## 93037, 93061, 93070, 93102, 93121, 93132

CITROËN / FIAT / FORD / MAZDA / MINI / PEUGEOT / VOLVO

### ISSUE POSSIBLE OIL FLOW RESTRICTIONS

## PRE-FILTER INSIDE THE OIL FEED LINE

Removing the pre-filter from the oil feed line coupling

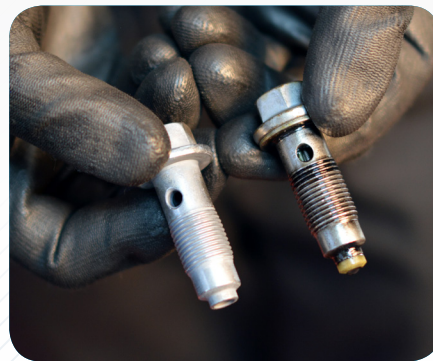
In some vehicle models, with the listed diesel engines, there is a factory installed pre-filter in the oil feed line to the turbo. The filter is mounted in the coupling on the engine side either as an insert filter or as a filter integrated with the banjo bolt. The very fine mesh of the filter makes it easy to clog it up due to impurities present in the oil (e.g. carbonized, hardened oil particles). The filter/mesh can also get loosened due to disintegrating from the coupling/banjo bolt. In both cases, it will cause feed oil flow restrictions. Consequently, the shaft lubrication gets impaired, resulting in serious failures of the turbo.

- **Depending on the OE version: Remove the factory-installed pre-filter from the oil feed line coupling or install a new banjo bolt without the filter**
- **Replace the oil feed line**
- **Perform engine flushing/cleaning to eliminate any sludge/carbonized oil particles**
